Access Compliance Report

Public Rights-of-Way

| Intersection ID: 43361 | Main Street: PROSPERITY COMMONS DR | Cross Street: RIDGEVIEW COMMONS DR | Location: E |
| ADA ID: 2122B3666FA2 | Ramp Type: PerpDiag | Initial Pass/Fail: Fail | Overall Compliance: No |

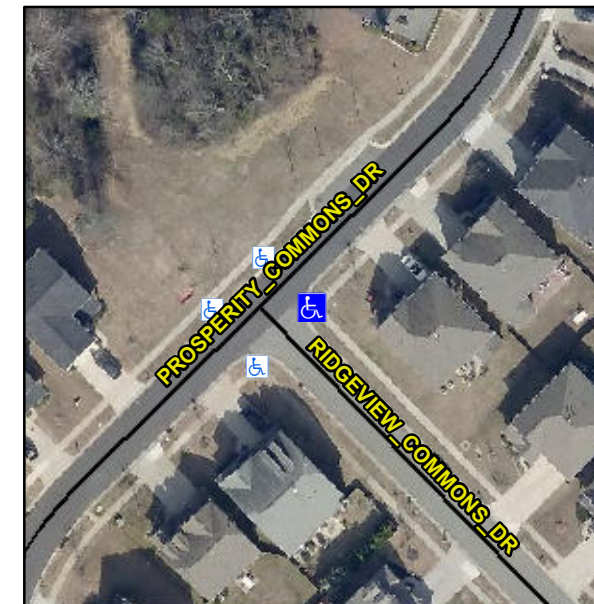
Not Found, R304.5.3

| Compliance | Description | Data | Compliance | Description | Data |
|------------|-----------------------|-------|------------|-----------------------------|-------|
| Yes | Ramp Width (in) | 48.0 | No | Ramp XSlope (%) | 3.5 |

Remove & Replace Curb Ramp With Two New Directional Ramps or Equivalent.
